Well Name: CORRAL 23-26 FED COM	Well Location: T25S / R29E / SEC 23 / SENW / 32.118156 / -103.956221	County or Parish/State: EDDY / NM
Well Number: 207H	Type of Well: OIL WELL	Allottee or Tribe Name:
Lease Number: NMNM120895	Unit or CA Name:	Unit or CA Number:
US Well Number:	Operator: XTO ENERGY INCORPORATED

Sundry ID: 2857358

Procedure Description: XTO ENERGY INCORPORATED respectfully requests approval to make the following changes to the approved APD. Changes to include well name. The proposed well name is changing from Corral 23-26 Fed Com 207H to Corral 23-35 Fed Com 208H. The APD ID for the well is: 10400098964; API number for this well is 30-015-56706.

Sundry ID: 2858111

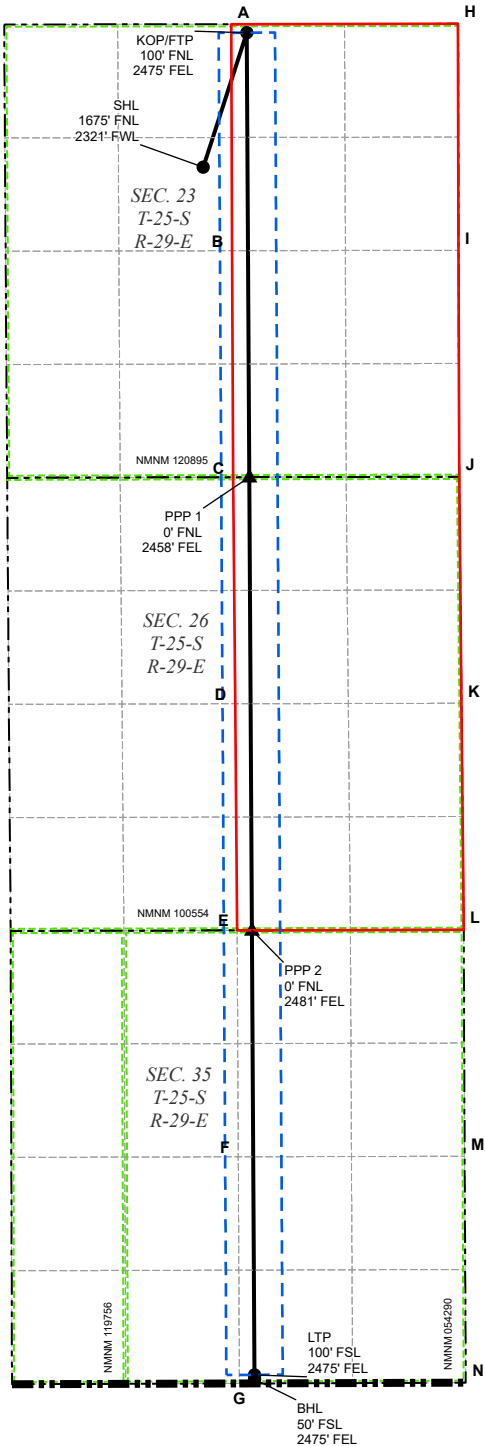
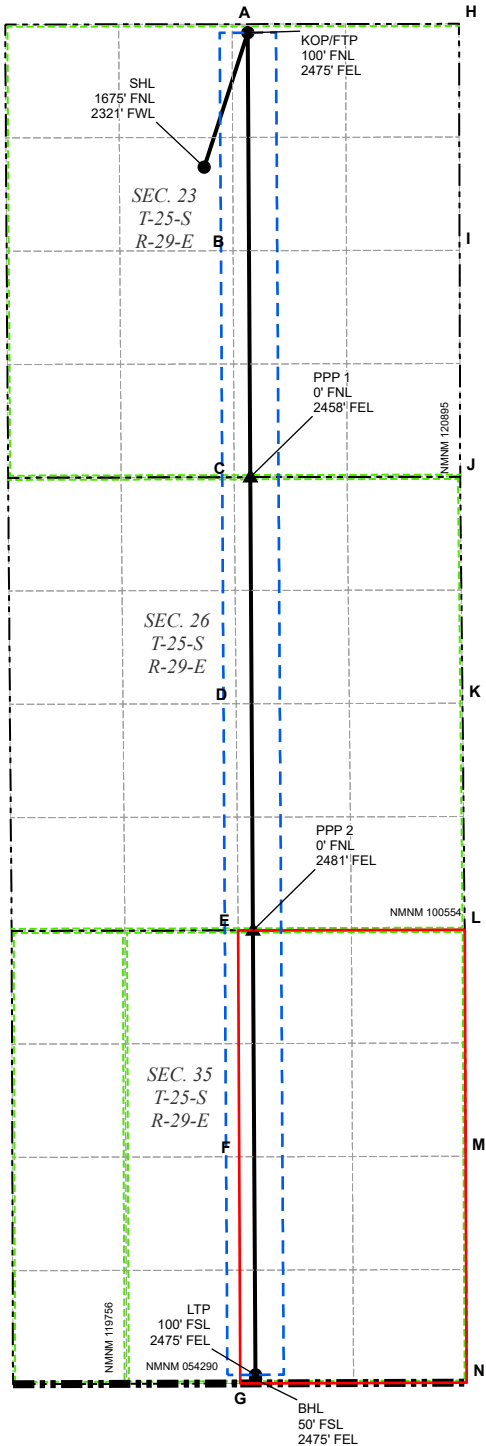
Procedure Description: XTO Energy Inc. respectfully requests approval to make the following changes to the approved APD. Changes to include KOP, FTP, LTP, BHL, Proposed total depth, Pool, and dedicated acreage, Formation TVD, Casing Design, Cementing Program, Mud Program. APD ID 10400098964; Well API: 30-015-56706 FROM: TO: KOP: 1675' FNL & 2321' FWL OF SECTION 23-T25S-R29E 100' FNL & 2475' FEL OF SECTION 23-T25S-R29E FTP: 330' FNL & 2430' FWL OF SECTION 23-T25S-R29E 100' FNL & 2475' FEL OF SECTION 23-T25S-R29E LTP: 330' FSL & 2430' FWL OF SECTION 26-T25S-R29E 100' FSL & 2475' FEL OF SECTION 35-T25S-R29E BHL: 50' FSL & 2430' FWL OF SECTION 26-T25S-R29E 50' FSL & 2475' FEL OF SECTION 35-T25S-R29E The proposed total depth is changing from 21352' MD; 10363' TVD to 25330' MD; 9523' TVD The pool is changing from PURPLE SAGE, WOLFCAMP (GAS) to WILLOW LAKE; BONE SPRING, SOUTHEAST & CORRAL CANYON: BONE SPRING, SOUTH. The dedicated acreage is changing from 1280.00 to 640.00 & 320.00. There is no new surface disturbance. See attached drilling program for the Updated formation, casing design, cement program and the mud circulation system.

UL	Section	Township	Range	Lot	Ft. from N/S	Ft. from E/W	Latitude	Longitude	County
O	35	25S	29E		100 FSL	2,475 FEL	32.079246	-103.954438	EDDY
